CITY OF ALBUQUERQUE

**RE: Velasquez Residence
8701 Glendale NE
Grading & Drainage Plan
Engineer's Stamp Date: 5/28/25
Hydrology File: B20D069
Case # HYDR-2025-00192**

ENGINEER'S SEAL	LOT 24 BLK 16 U 3 NAA 8701 GLENDALE AVE. NE	DRAWN BY DEM
DAVID SOULE REGISTERED PROFESSIONAL ENGINEER 14522	GRADING AND DRAINAGE PLAN	DATE 11-1-24
5/28/25	Rio Grande Engineering	8701 Glendale Ave NE, DING
DAVID SOULE P.E. #14522	ALBUQUERQUE, NM 87199 (505) 321-8099	SHEET # C1
		JOB #

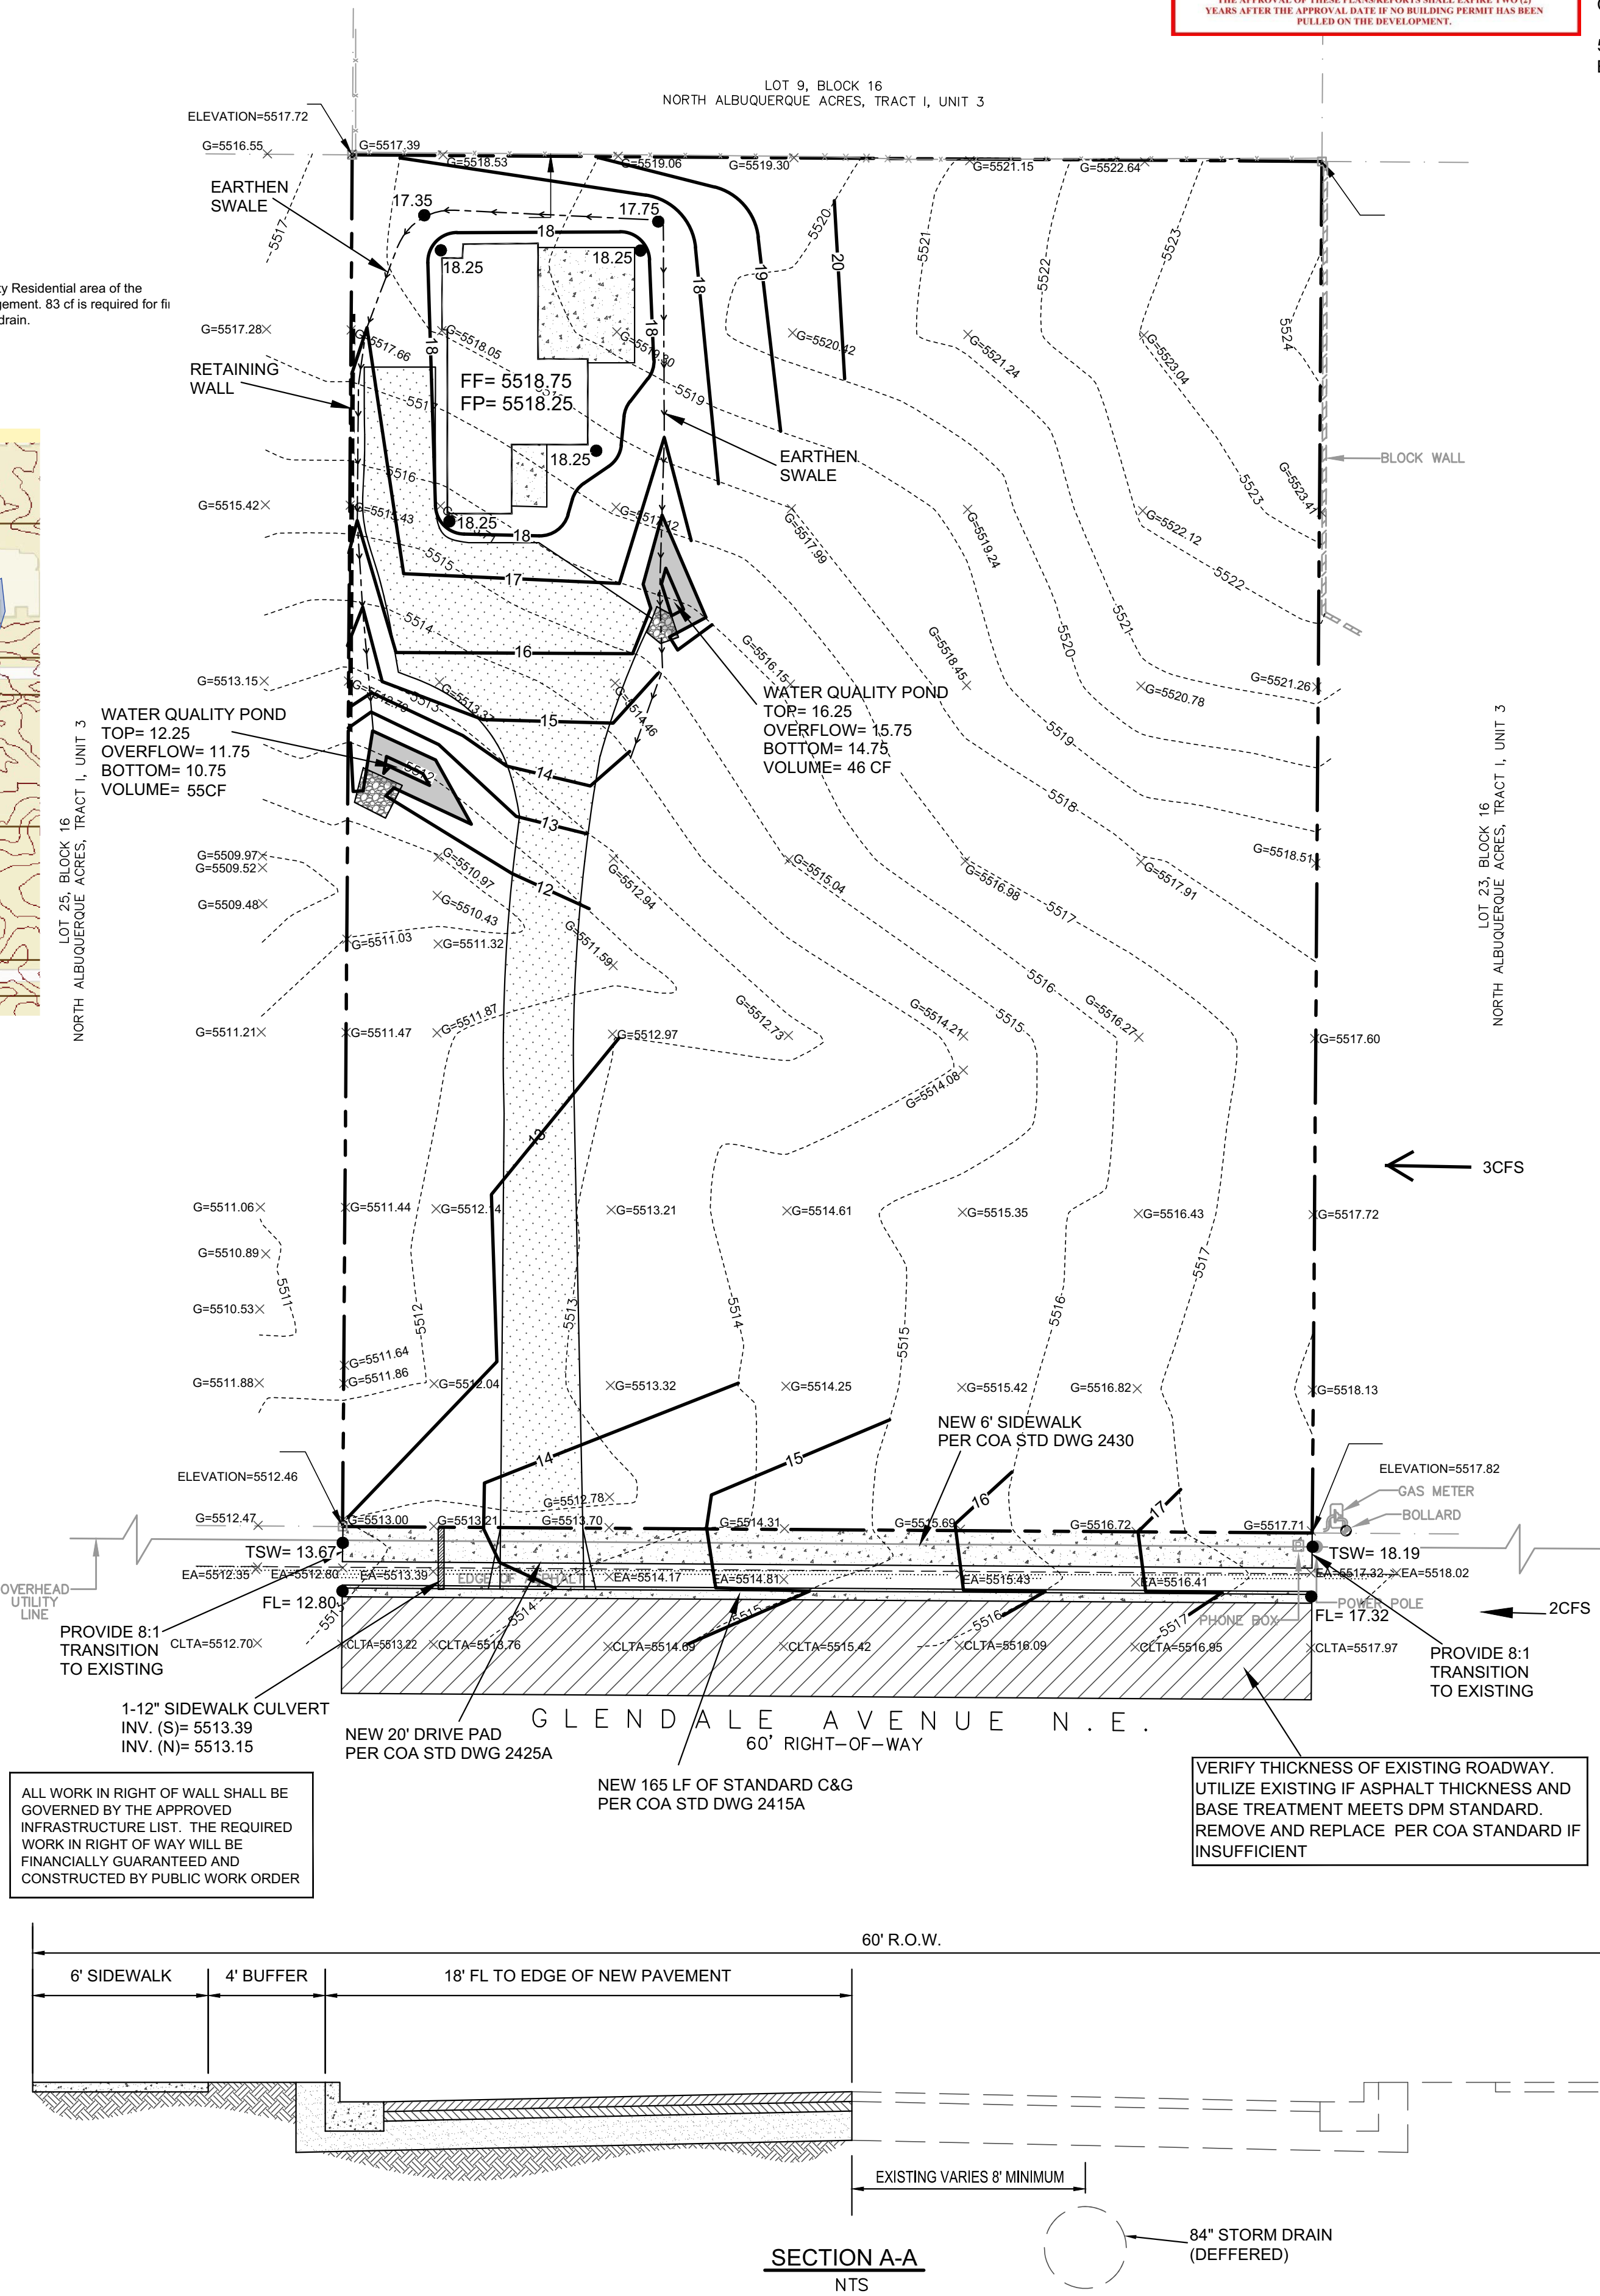
Based upon the information provided in your submittal received 5/28/2025, the Grading plan is **approved** for Building Permit and Grading Permit. Please attach a copy of this approved plan in the construction sets for Building Permit processing along with a copy of this letter.

1. Engineer's Certification, per the DPM Part 6-14 (F): *Engineer's Certification Checklist For Non-Subdivision* is required.
